City of NAPOLEON, OHIO

Re: 950 Melody Lane
Lot 15 - Brickyard Subdivision

VAULTED CEILING FRAMING ~ 16" o/c

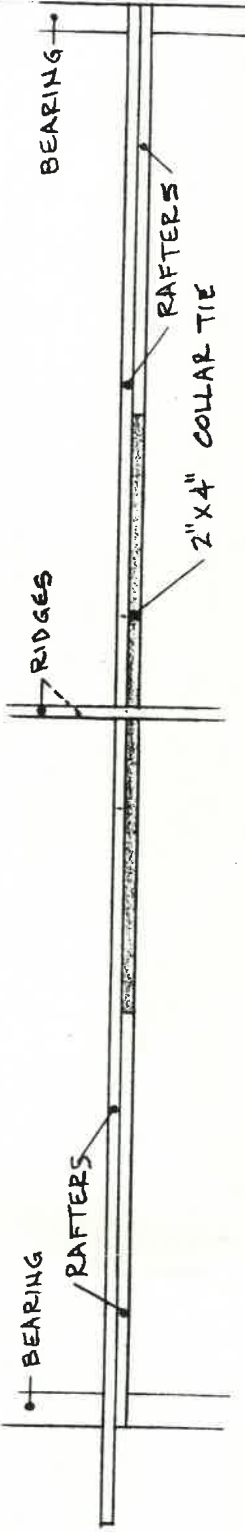
- X 1) Plumbing isometric.
- X 2) Heating layout.
- X 3) Provide a section thru the vaulted ceiling areas showing the framing method.
- X 4) Resubmit the site plan with the required sidewalks shown.

- 5) Increase the rafters to 2 x 8's @ 16" O.C.
